35/13-06U 4 Primrose St
Chevy Chase Village Historic District, 35/13

HISTORIC PRESERVATION COMMISSION

SUBJECT: Historic Area Work Permit #421255, fence replacement

PROPOSAL: fence replacement

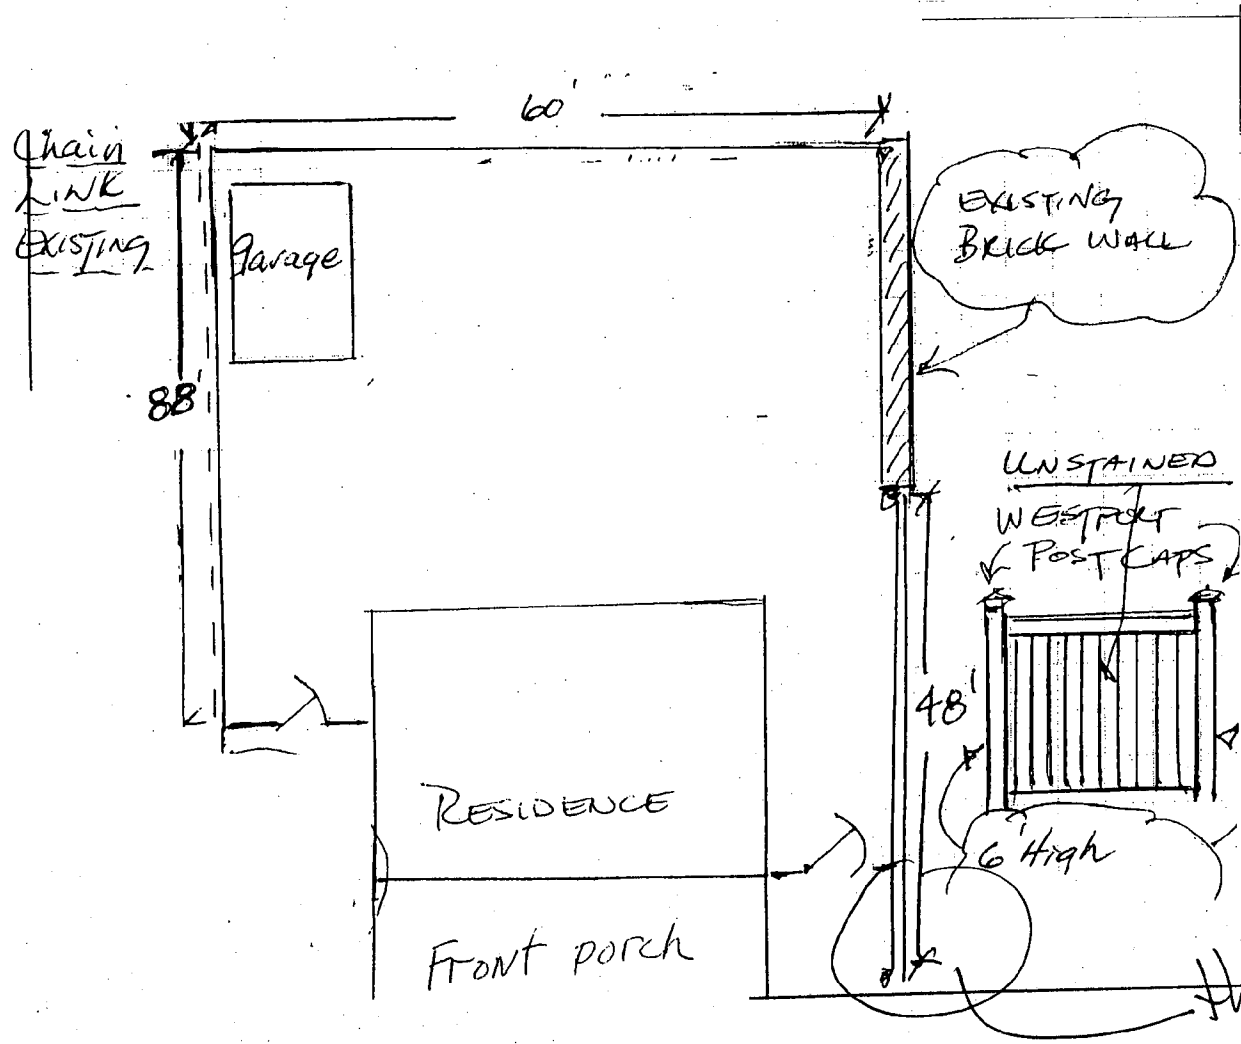
this portion can be no taller than 48 inches

1. No fence equal to or greater than 6' will extend beyond the front plane of the house.
